Value Engineering Study
***US 127 FROM KY 90 TO
JAMESTOWN BYPASS***
CLINTON & RUSSELL COUNTY, KENTUCKY

***ITEM NUMBER 8-108.00 & 8-115.10
VE STUDY NUMBER 201102***

Study Date: February 28 -
March 4, 2011

Final Report

VALUE ENGINEERING RECOMMENDATION # VE-3

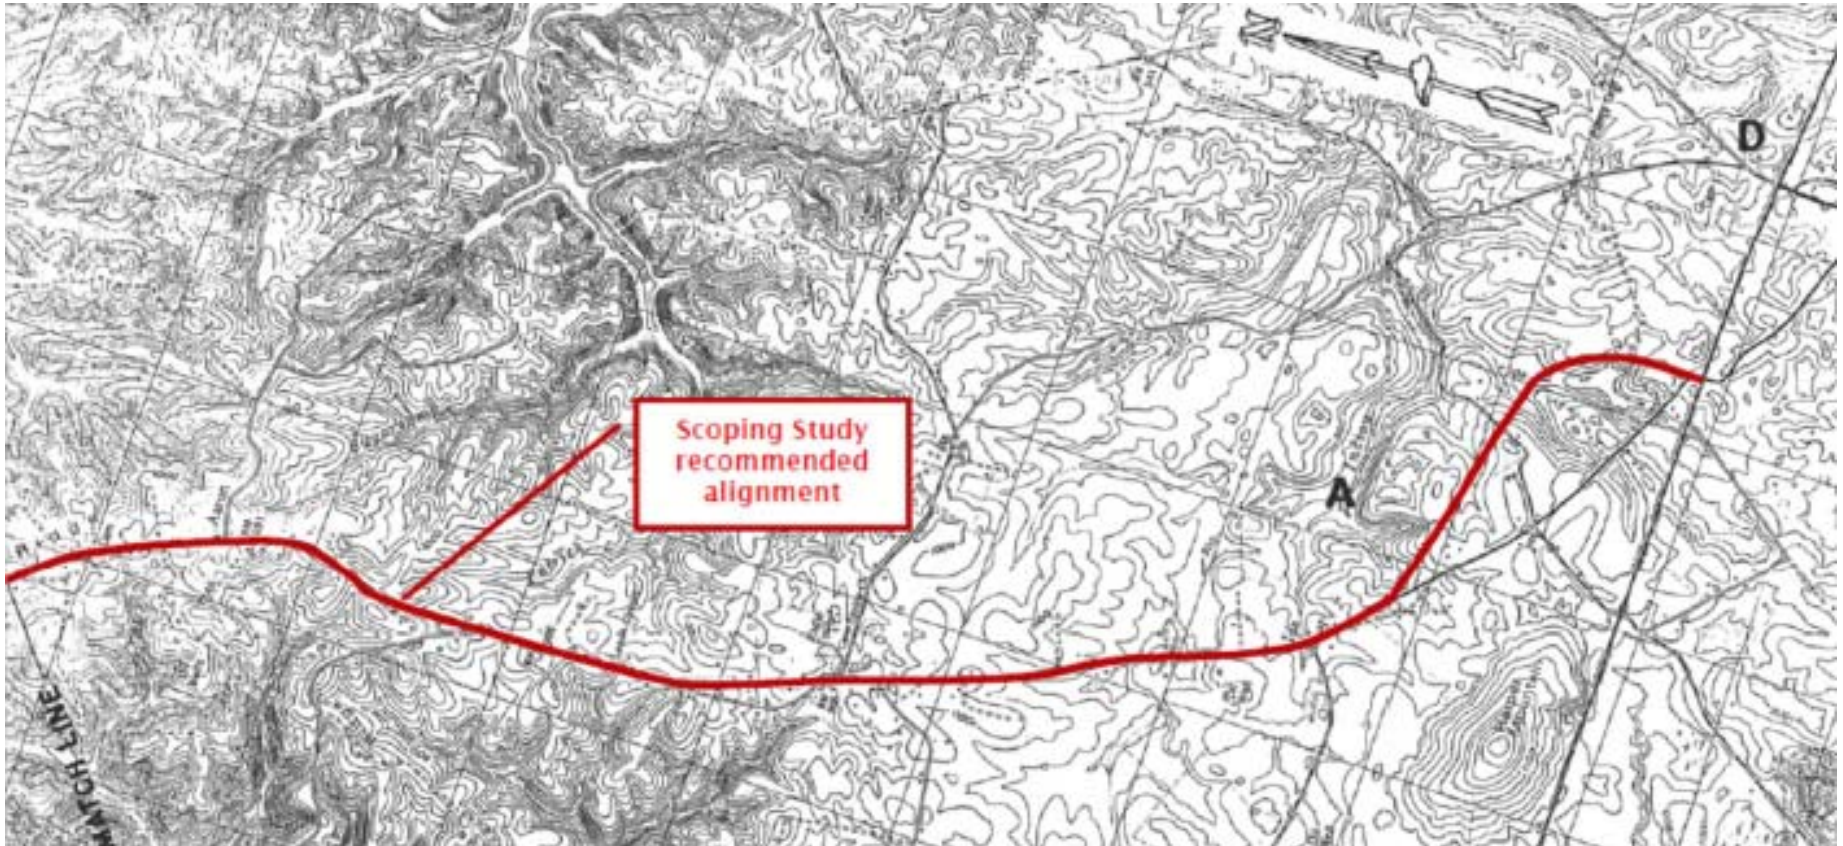
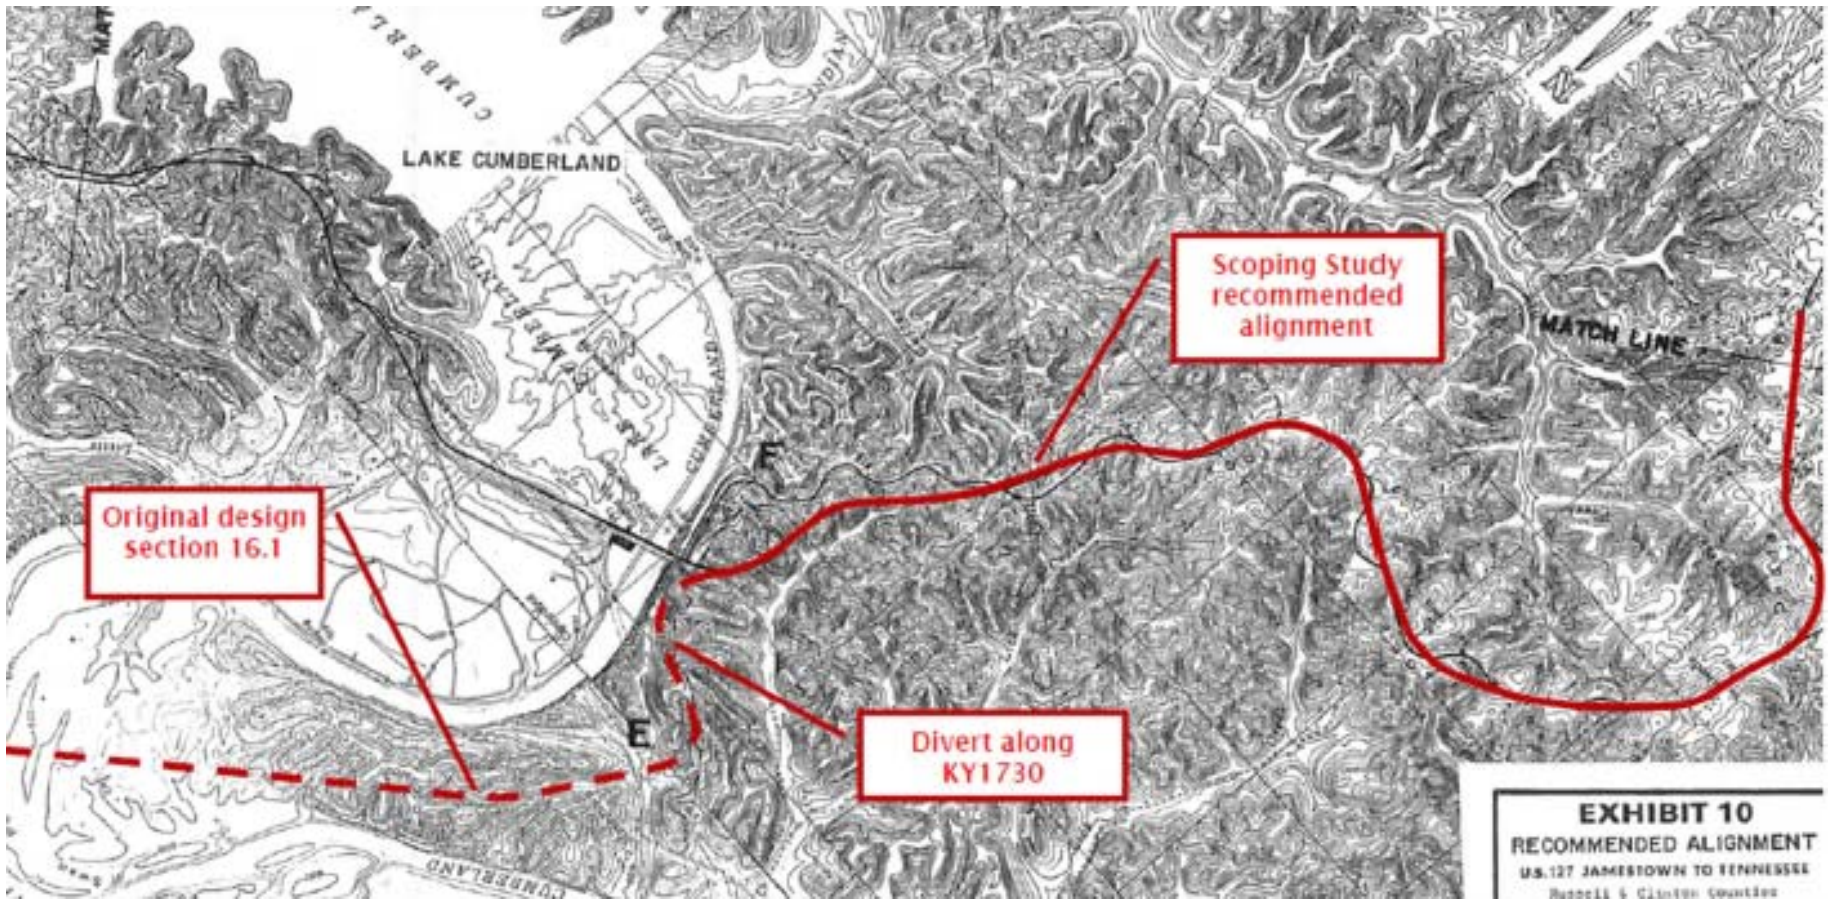
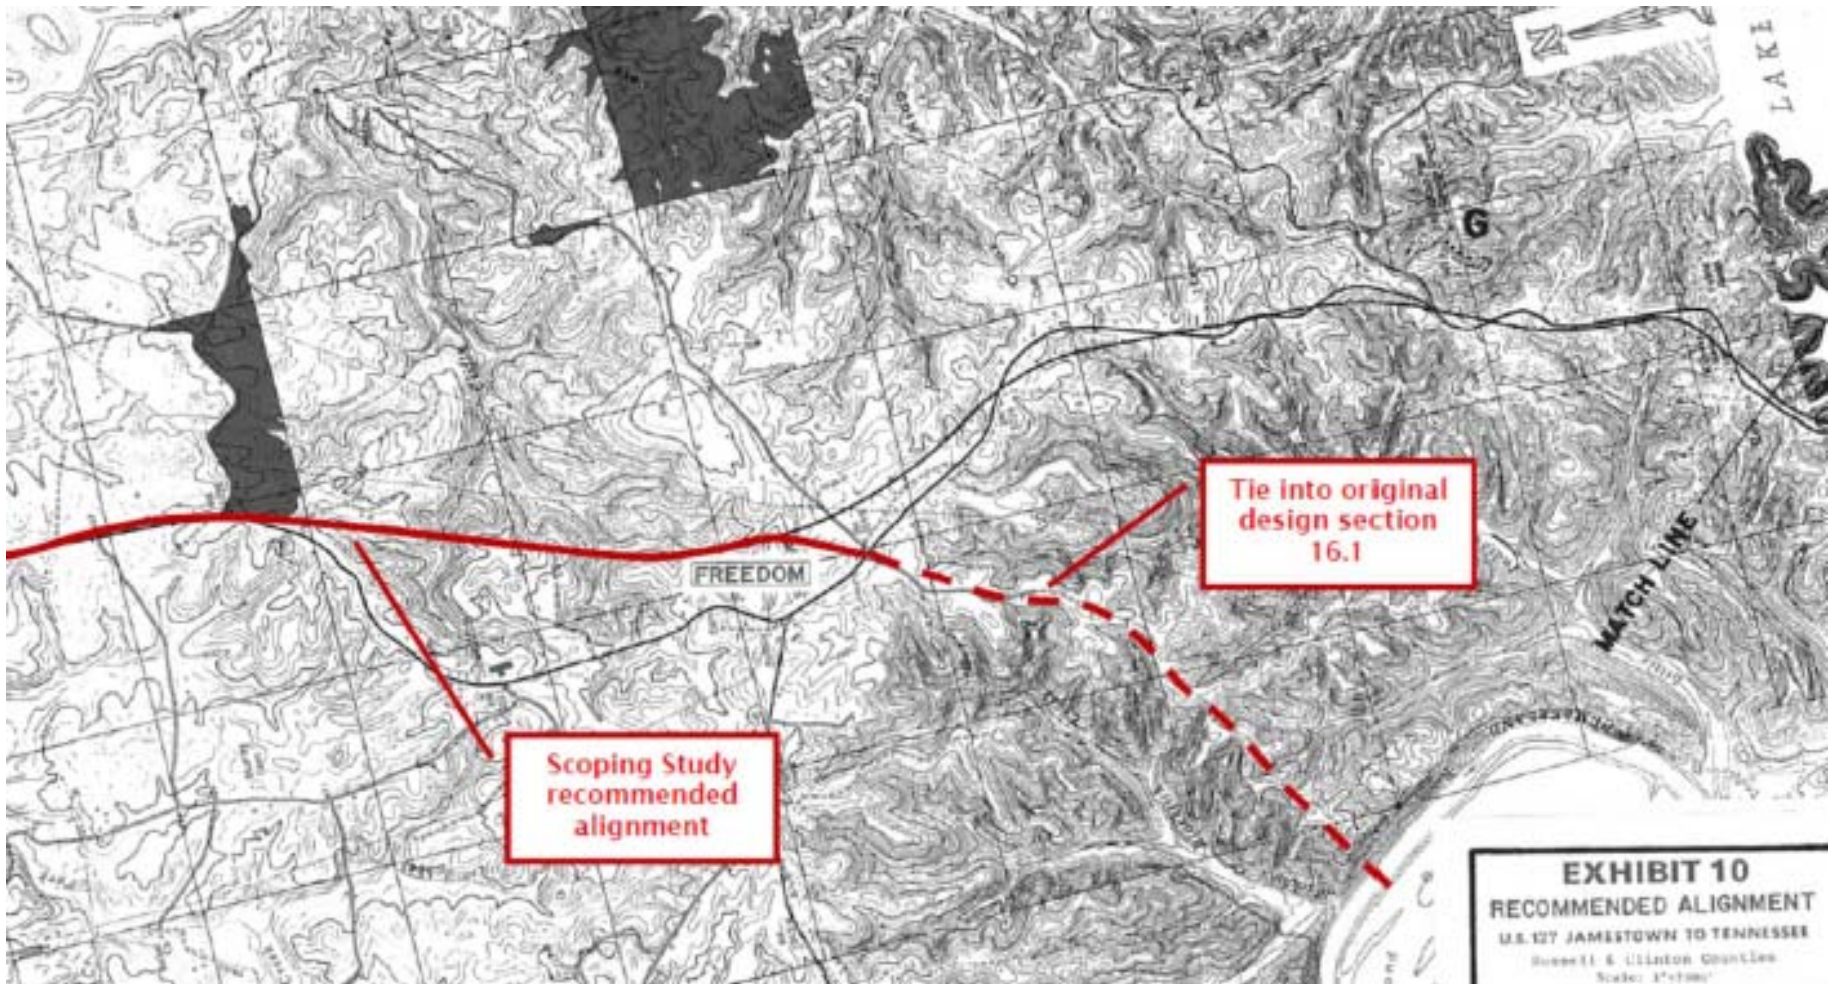
Utilize the 1990 scoping study alignment diverted around Wolf Creek Dam in lieu of the base case design.

The VE team recommends that the project team reconsider the alignment that was recommended in the 1990 Scoping Study, US 127, Jamestown to Tennessee. This alternative assumes that the project still requires that the road be diverted around the Wolf Creek Dam. The alignment follows the same basic alignment as the existing US127 from the southern termini until KY 1730, just south of the dam. From there, the VE team recommends that it would follow the KY 1730 alignment and tie into Design Section 16.1. The alignment proposed in the study meets 60 mph design speed and assumed 12 ft travel lanes and full width shoulders.

Although the environmental assessment considered reconstruction on the existing alignment (Alternative II, Rebuild the Existing Road), it was eliminated from “further study for reason that include failure to meet purpose and need related to removal from atop Wolf Creek Dam.” However, it did not consider a combination of existing alignment and new alignment to avoid the dam. This VE alternative meets both purposes identified in Environmental Assessment: removing the principal arterial from atop the dam and improving geometrics. This alternative would reduce the cost to a level that would allow the entire project to be funded much sooner.

VALUE ENGINEERING RECOMMENDATION # VE-4

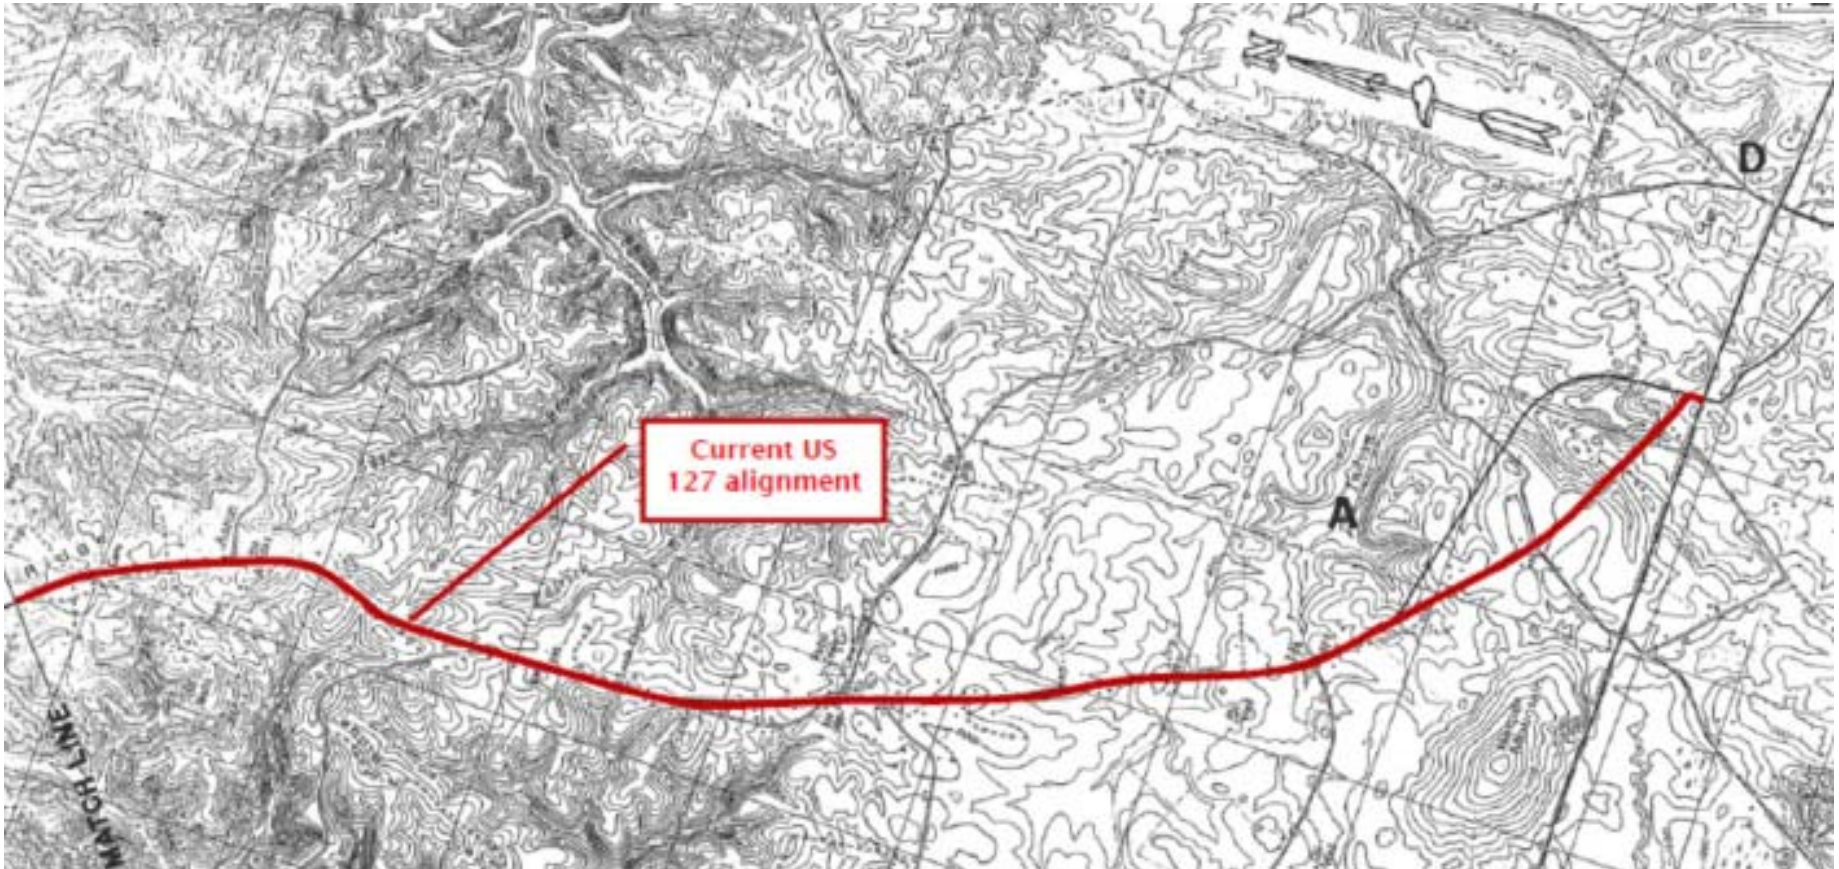
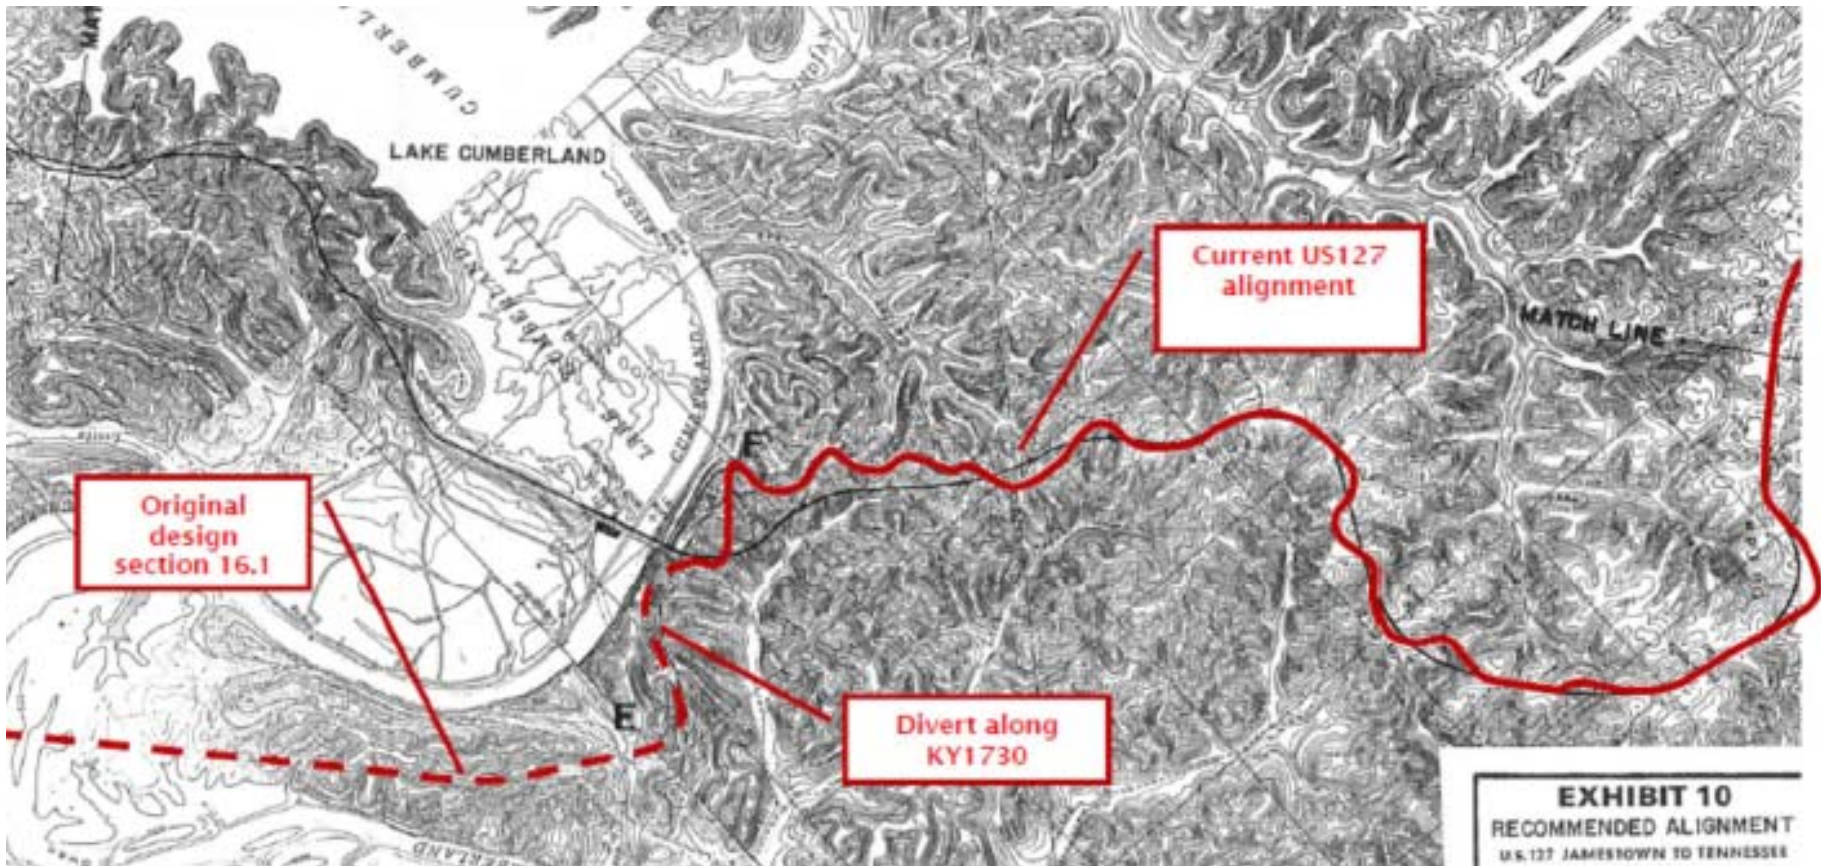
Utilize existing US 127 alignment from KY 90 to KY 1730, and follow KY 1730 to proposed alignment 16.1.

The VE team recommends using the existing US 127 corridor from KY 90 in Clinton County to KY 1730 in Russell County, then make an improved connection along KY 1730 to tie into a relocated US 127, identified as Segment 16.1 on the Preferred Alternative D.

This recommendation is justified given the lack of identified funding for the project and a desire to make some level of improvement. Also, the existing US 127 has an ADT of approximately 3,300 and based on the material provided for the VE study, it does not appear to be a safety problem along the route.

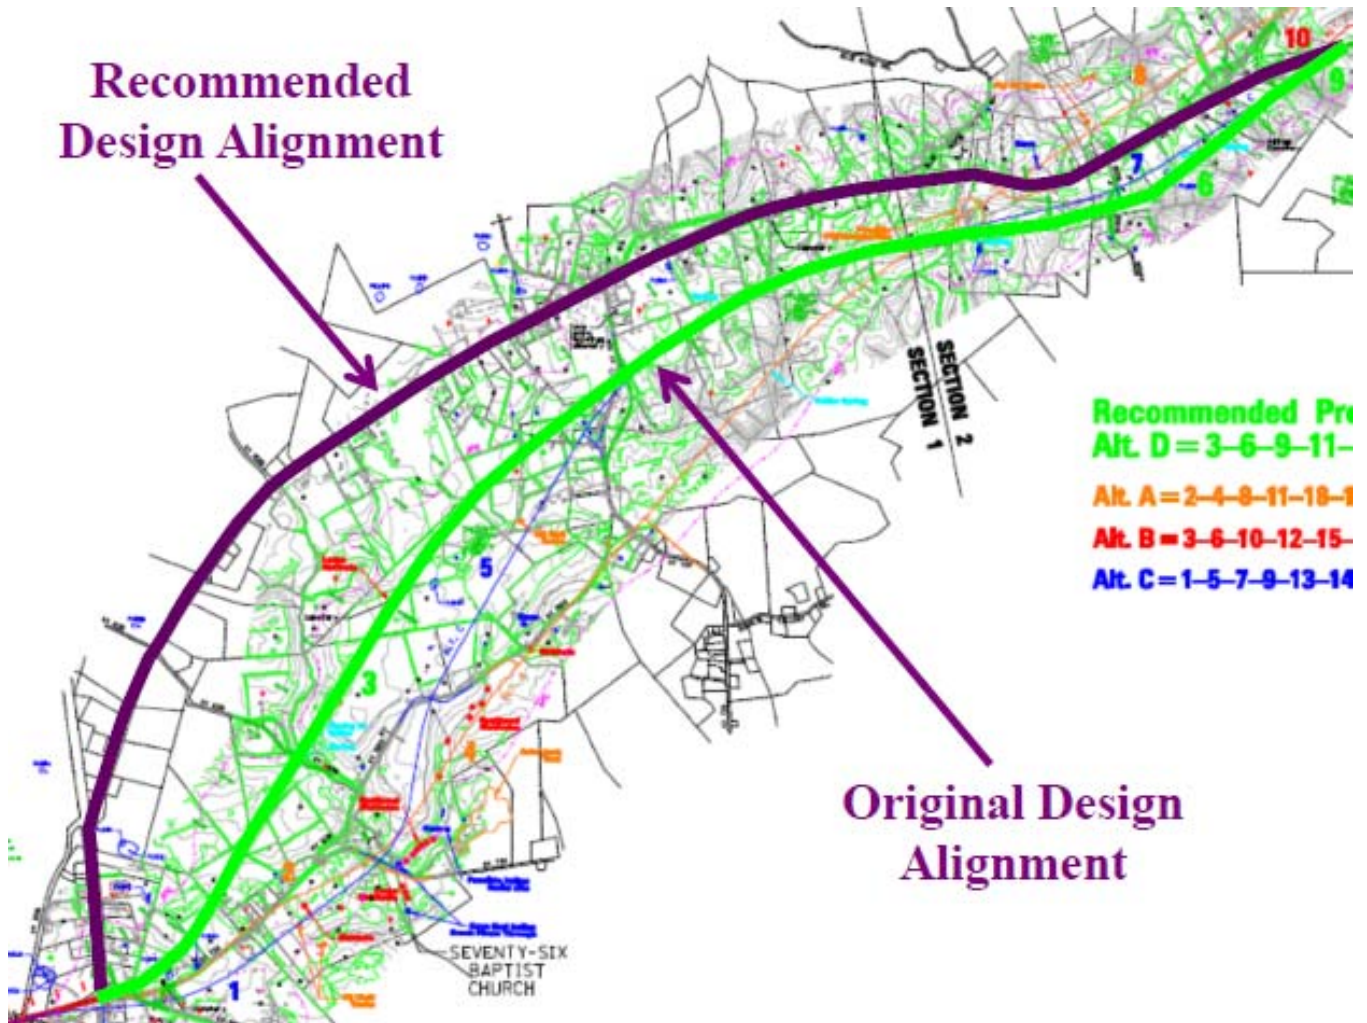
Existing US 127 in Clinton Co. (KY 90 MP 11.017) to Station 285+00 = 5.9 miles

Cost assumption for rebuild of US 127 is based on the cost of construction section 3 provided by the designer ($\$21,890,374 / 5.89 \text{ miles} = \$3,716,532 \text{ per mile}$). Based on 50% savings due to pavement reuse, reduced rock excavation, reduced embankments and other miscellaneous items, cost per mile for rebuild is: ($\$3,716,532 \times 0.5 = \1.85 M / mile ; Say \$2 M / mile)
